**YAMAHA**

**PARTS CATALOGUE**

**GOLF CAR**

# TECHNICAL BULLETIN

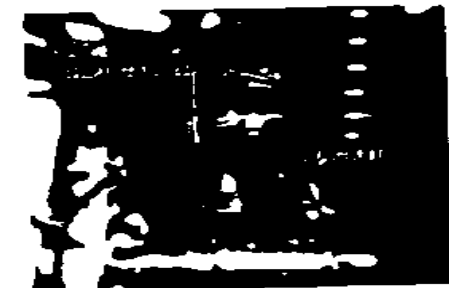
YPOI now stocks an exhaust tailpipe bracket which will allow repair of a broken bracket without replacement of the entire muffler assembly. This new tailpipe bracket should be used whenever repairing a cracked bracket. Do not perform this modification unless the bracket has cracked.

1. Remove the rear body panel. Remove the muffler assembly.

3. Remove the nut on the right rear engine mount.

PART NUMBER	DESCRIPTION	REMARKS	DEALER COST
90891-60033-00	Bracket Kit G-2	1 per car

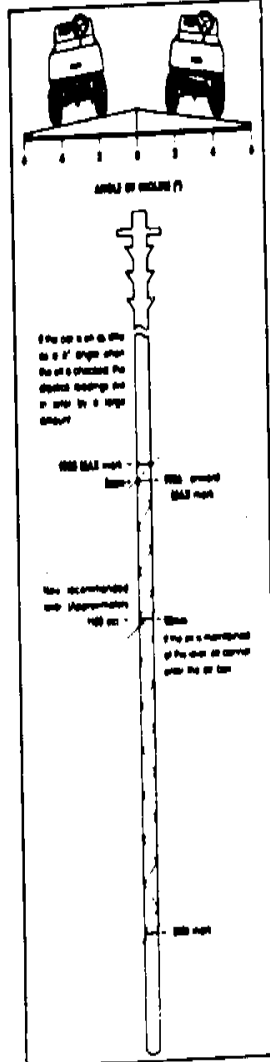
Customers should be cautioned that the oil level should be checked only when the car is on level ground. As seen in the illustration, with the car on as little as a 6° incline (normal road drainage pitch is about 4°), the dipstick can be easily misread.

By reducing the oil level in the engine to approximately 100 cc, this problem will no longer occur.

When adding or changing oil, the engine should be filled with 100 cc of oil. This amount lowers the oil level to a point on the dipstick between the MAX and MIN marks, about one-third the distance below the MAX mark (2mm). Do not fill above this point. This slightly reduced oil level will not affect lubrication. The oil level warning system still gives ample notice when oil must be added.

If desired, the dipstick can be remarked at the level indicated after an oil change. As usual, make sure both the dipstick and the oil-filter cap are firmly in place after any oil servicing to ensure proper circulation of oil in the cylinder head and that the governor is adjusted to factory specifications.

## PLUNGER ADJUSTMENT (Cont'd.)

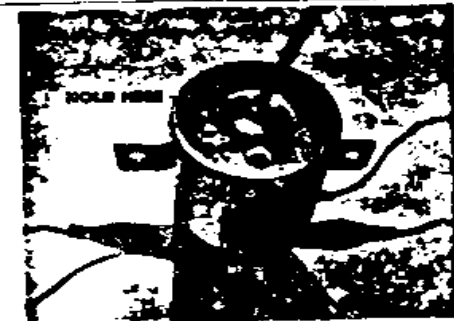
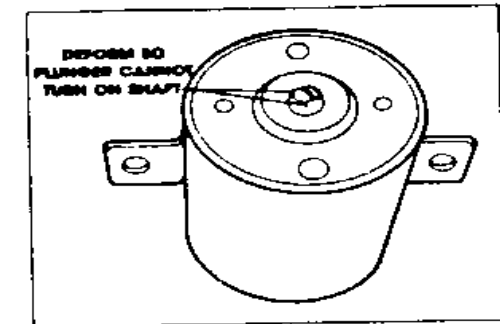
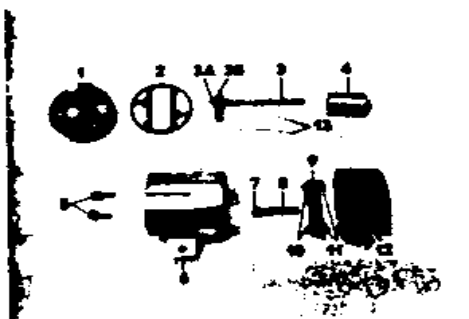
- Apply a light coating of high-temperature grease inside the body.
- Install the new shaft assembly in the solenoid body. Then, install the old insulator and spring over the threaded end of the shaft.
- Hold the contact plate to prevent the shaft from turning, and screw the new plunger onto the shaft until it reaches the end of the threads. Then, back it off 1/2 - 3/4 turns.
- Clean the contacts on both the shaft assembly and cap.
- Remove all excess solder from the two coil wires.
- Make sure the wires are straight (Remember, they are very fragile), and carefully install the guide tubes over them.
- Install the new end cap and seal over the guide tubes.
- Remove the guide tubes and discard them. Solder the wires to their terminals.

- Install the collars, the plate, the screws, and the rubber cover.

- Reinstall the solenoid, and check solenoid operation.

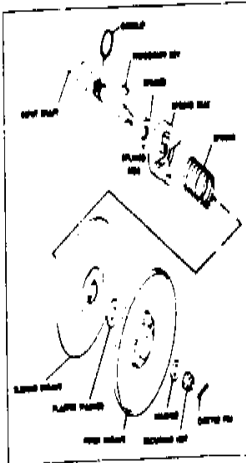
**REMEDY** Replace the spring seat circlip with the new spacer.

### SERVICE PROCEDURES

1 Follow service manual instructions to remove the rear body and the secondary clutch fixed sheave.

2 Remove the plastic washer, woodruff key, sliding sheave, and spring seat. Remove the circlip. Tag the circlip with a Warranty Parts tag and hold for 90 days from the date the Warranty Request is submitted. The circlip is not used with the new spacer.

**NOTE:** Pay special attention to the service manual procedures for installing the spring and sliding sheave. Correct installation of the spring and sliding sheave is critical for proper operation.
